**Belfast
City Council**

PLANNING COMMITTEE

- (e) LA04/2023/2748/A - 1 Digital Advertisement Display - 12-13 Shaftesbury Square (Pages 3 - 14)

Development Management Officer Report Committee Application

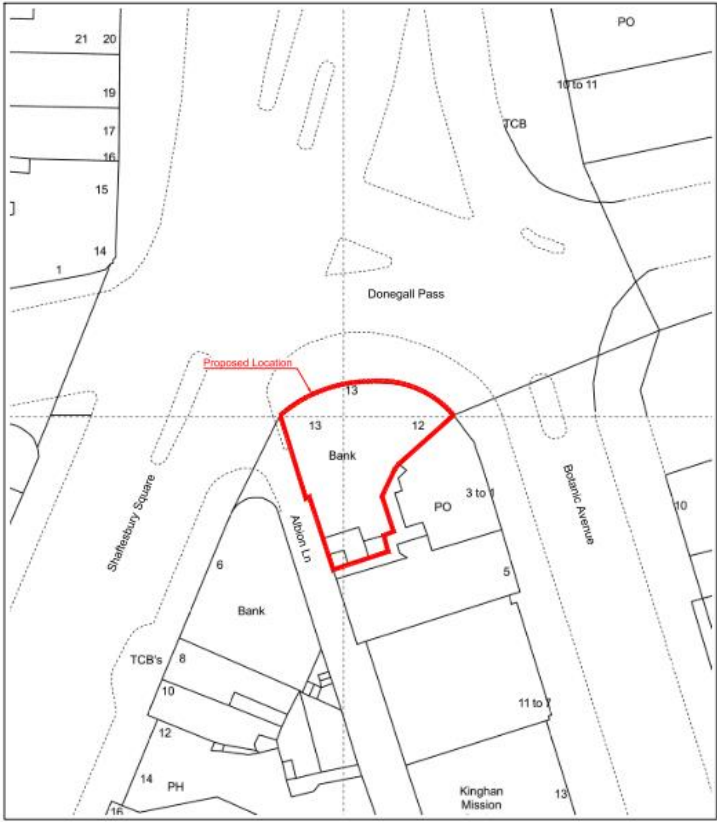
6.4.5	<p>The SPG states that digital and LED signs are more suitable in predominantly commercial areas, industrial areas or along transport corridors and areas with larger buildings where signage can be integrated more effectively into architecture. The site is located within a mixed-use area comprising offices, student accommodation, restaurants, hotel, retail uses etc. However, the proposed LED sign is considered to be too large, dominant and out of scale with the host building.</p>

6.4.6	<p>The initial drawings submitted with the application proposed an LED sign which measured 20m (length) x 5m (height). During the processing of the application, officers Dfl Roads and HED met with the applicant to discuss concerns and amended drawings were received seeking to address issues raised in respect of amenity, road safety and impact on the adjacent listed building. The most recent amendment shows a reduction in size to 16m (length) x 4m (height).</p>

6.4.8	<p>The proposed digital sign would project above the parapet by approximately 1.8m and would obscure key architectural features such as the mutilated cornice, in contravention of the SPG. Whilst it is acknowledged that the existing sign obscures some key features, the proposed sign would be 9.2m longer than the existing sign and 0.2m higher and would be located approximately 1.3m from the edge of the building on both sides. As a result, a substantial part of the building's key features at parapet level would be obscured. The sign itself is approximately 3m in depth and would be highly visually prominent when viewed from surrounding streets including Botanic Avenue and Donegall Pass. It is considered that the sign would be visually prominent in the streetscape with short and medium range views available including views on approach from Great Victoria Street. Given the significant size of the sign and proposed location at high level along with the digital format, the proposal would be unacceptably prominent and harmful in the street scene and of a scale which would adversely impact the character and appearance of the area. The proposed sign would also be an overly dominant feature on the host building and would be significantly harmful to the visual amenity of the area.</p>

6.5.4	<p>HED has objected to the application on the grounds that the proposal would negatively impact on the setting of the Grade B2 Listed building at 2-6 Bradbury Place. They advise that '<i>The listed building of 2-6 Bradbury Place is positioned on the junction of Shaftesbury Square, Donegall Road and Bradbury Place. A key feature of the building is how it has been designed to be read on the approach from the Dublin Road as the listed building 'addresses' this approach - as expressed by the curved façade design towards the junction. We add that 1 Bradbury Place, Malone Lower (HB26 29 031), although not listed, has also been designed to 'address' the junction of Shaftesbury Square, Donegall Road and Bradbury Place. Again, notable due to the curved façade at the junction.</i>'</p> <p><i>'HED acknowledge the existing illuminated signage on the application site, albeit significantly smaller in size than the current proposal. The proposed 20m x 5m, Digital Advertisement Display would form a continuous band across the full of the application building's façade. Due to the increased size and nature of the proposed moving/kinetic electronic signage screen, we consider the installation would have a detrimental impact on the setting of the listed building, due to its scale, form, height, alignment and would</i></p>

6.6.4	<p>DFI Roads advises that <i>‘the proposed digital display is significantly larger than the current display and would therefore intensify the risk of driver distraction’</i>. They go on to say that <i>‘this proposal conflicts with’</i> the SPG, Para. 4.6.2 (b) <i>in that it would, if permitted, prejudice the safety and convenience of road users. Since the erection of this proposal,</i></p>

8.0	Recommendation
8.1	Having regard to the development plan and other material considerations, the proposal is considered unacceptable. It is recommended that planning permission is refused.
